Agenda
HAILEY PLANNING & ZONING COMMISSION
April 18, 2022
Virtual and In-Person Meeting
5:30 p.m.

STAFF REPORT
Hailey Planning and Zoning Commission
Regular Meeting of April 18, 2022

S.V. AUTO CLUB
 STORAGE WAREHOUSE - SHOWROOM
 1930 EMBRAER WAY, HAILEY, ID. 83333

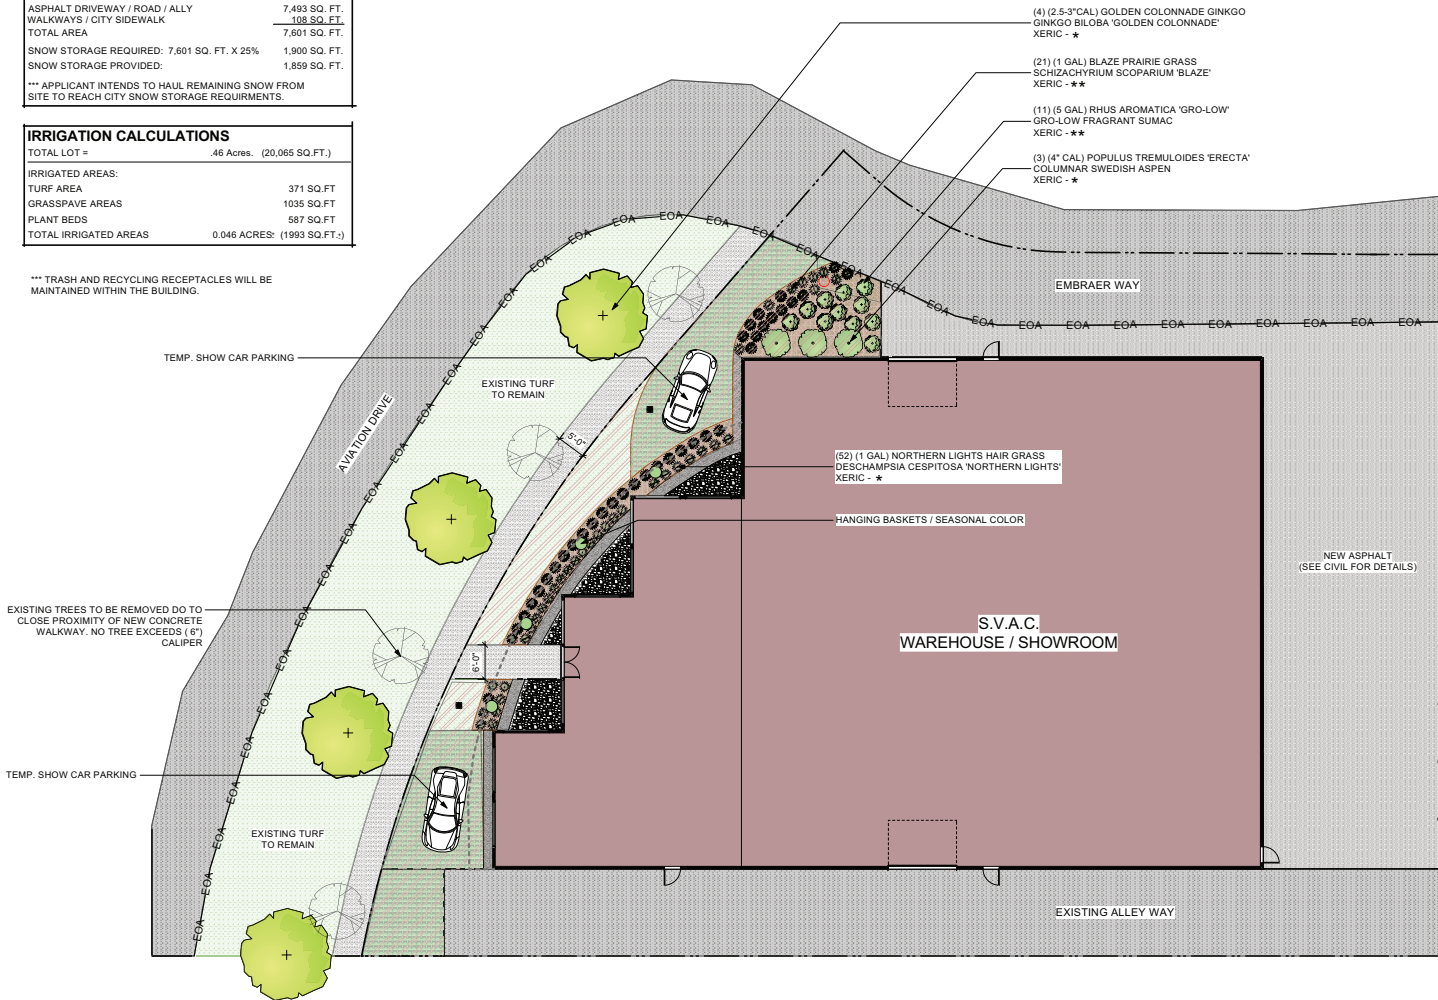
- **Consider replacing the existing street trees with trees deemed appropriate by the Hailey Tree Committee.** During the Design Review Application hearing, the Applicant explained how the water main is located directly under the existing street trees, which are 20-years-old. The water main has restricted the growth of these trees, and they have been unsuccessful in reaching an appropriate caliper since being planted in 2002. On April 14, 2022, the Hailey Tree Committee will meet to discuss the project. The Hailey Tree Committee Memo will be brought to the hearing on Monday, April 18, 2022.

- **Consider obtaining a new survey for the water main and culvert.** The Applicant acquired a new survey for the water main and culvert, which is attached to this report. The new drawing displays a landscape drywell, 30"-diameter catch basin, and a disconnected and removed water meter valve.

SUN VALLEY AUTO CLUB - FRONT ELEVATION

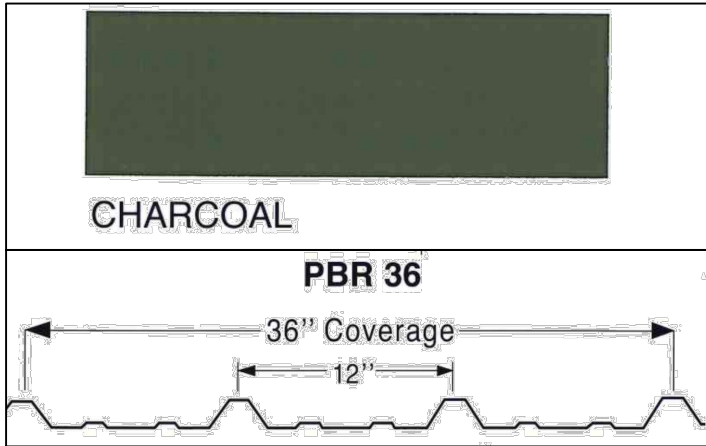
- **Consider breaking the southern elevation wall plane with design elements.** The Applicant submitted new design plans which displays new windows along the southern wall plane. The proposed windows match the other windows around the warehouse.

At the April 4, 2022 public hearing, the Commission suggested that the Applicant consider breaking up the southern elevation wall plane with design elements. The Applicant submitted new design plans which displays new windows along the southern wall plane. The proposed windows match the other windows around the warehouse.
<input type="checkbox"/>	<input type="checkbox"/>	<input checked="" type="checkbox"/>	17.06.080(A)2b	b. Standardized corporate building designs are prohibited.
			<i>Staff Comments</i>	<i>N/A, as the project is not a corporate design.</i>
<input checked="" type="checkbox"/>	<input type="checkbox"/>	<input type="checkbox"/>	17.06.080(A)2c	c. At ground level, building design shall emphasize human scale, be pedestrian oriented and encourage human activity and interaction.
			<i>Staff Comments</i>	<i>The building features street-level changes and incorporates large garage doors on the western and eastern wall for vehicular access into the warehouse. Exterior materials vary in color, shape, and size, which help to break up the mass of the buildings.</i>
